**Polonnaruwa Solar PV Power Project
(10 MWp)**

Tender No: CEB/EPT/SP/RFP1

Addendum No. 2

Ceylon Electricity Board

Annex B : Resource Block marked in the map

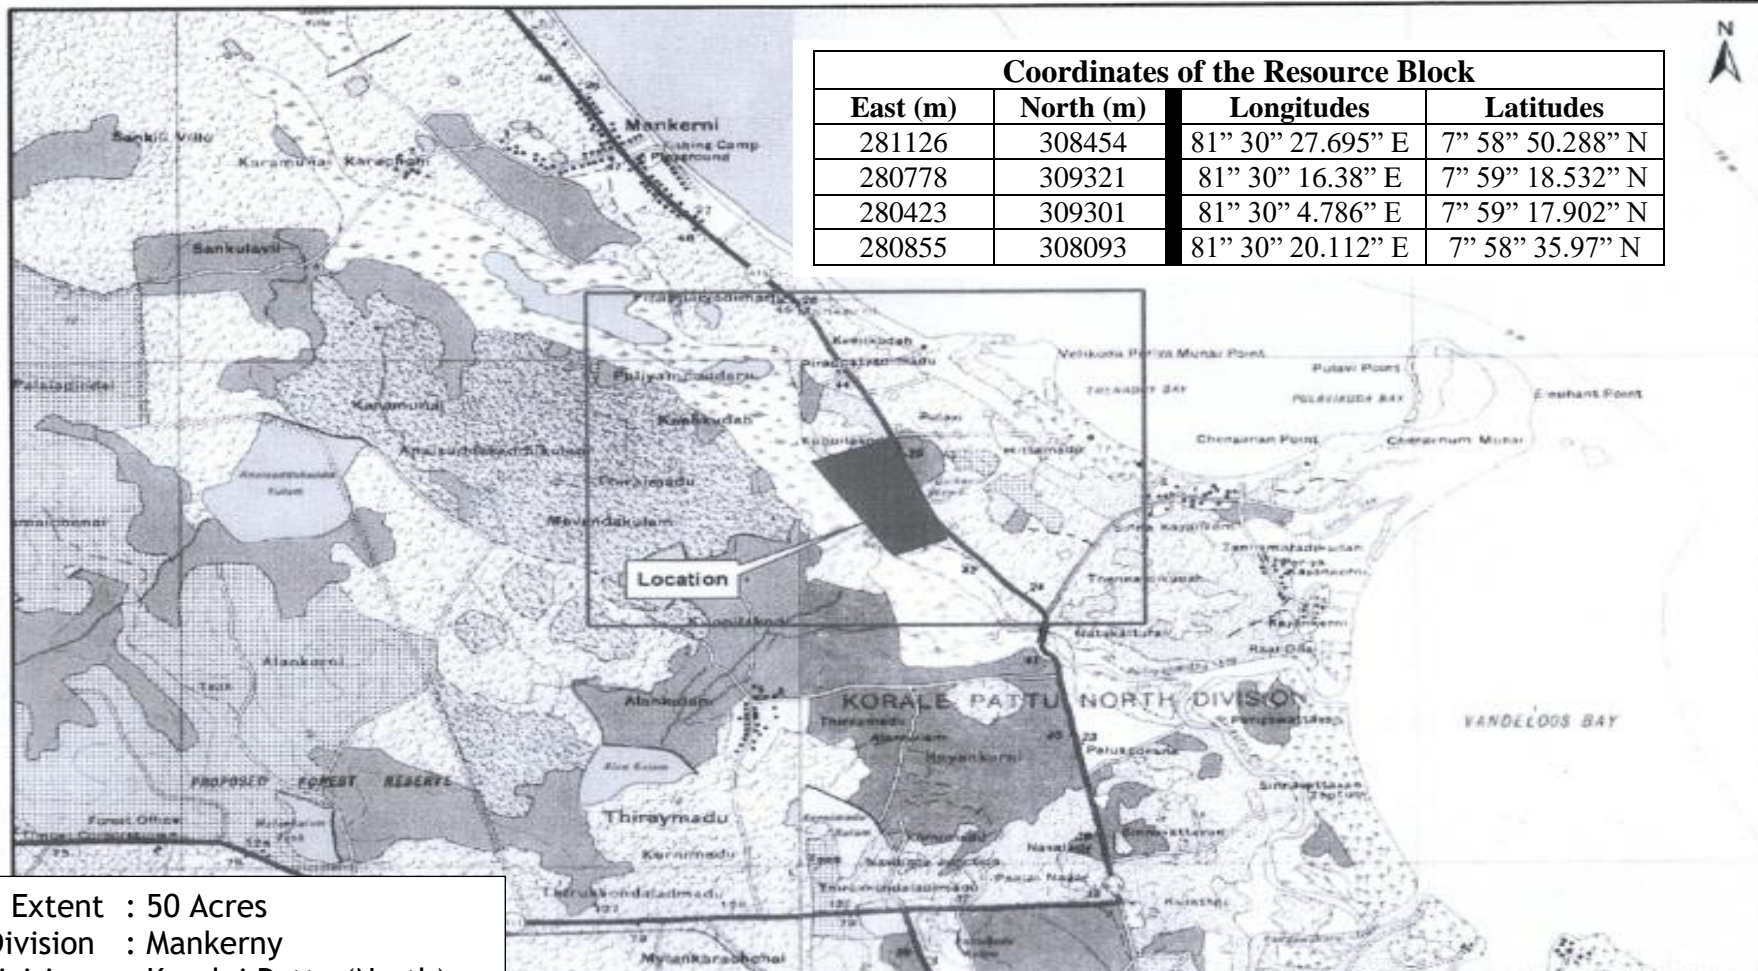
Annex B : Not Used

shall be **replaced** by

Annex B : Resource Block marked in the map (given below)

Land Extent : 50 Acres
 GN Division : Mankerny
 DS Division : Koralai Pattu (North)

(C) Volume 1 – Instructions to Project Proponents
Annex C: Details of the Interconnection

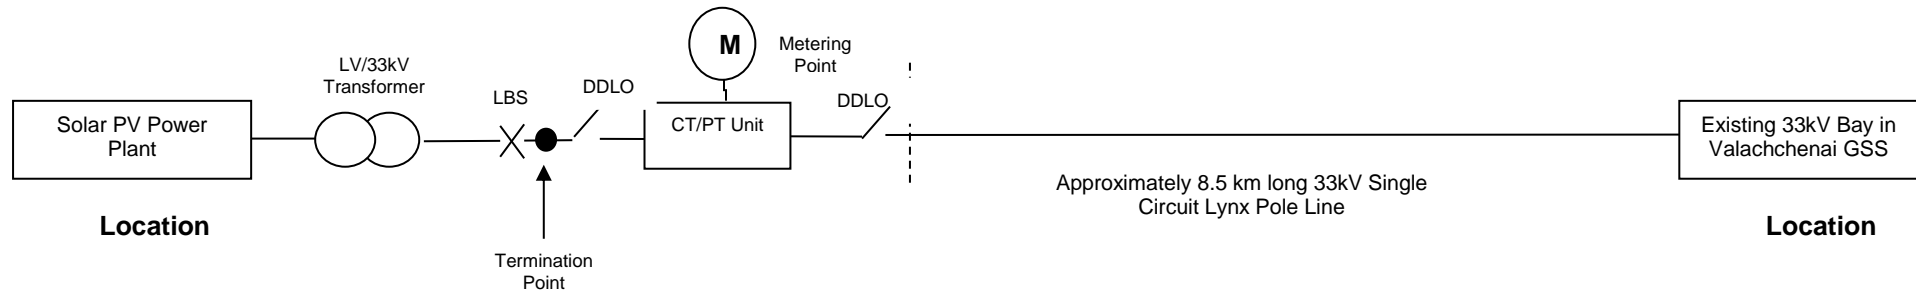
The above interconnection arrangement shall be **replaced** by the arrangement given below,

The above new arrangement is described below (**Description of Proposed Interconnection Arrangement**).

1. Construct approximately 8.5km long, 33kV, Single circuit, Lynx pole line (with 13m reinforced concrete poles) from the proposed Solar PV Power Plant at ‘Location B’ to the existing 33kV Feeder Bay at Valachchenai GSS (Location A).
2. 33kV Metering equipment should be installed at the power plant.
3. A remotely operated SF6 Load break switch (LBS) should be installed at the power plant before the energy meter (at ‘B’).

The successful Project Proponent shall design and construct the power transmission line/s including all associated equipment up to the Valachchenai Grid Substation at his own cost and expense. In addition cost for allocating the existing feeder bay at Valachchenai Grid Substation also has to be borne by the developer.
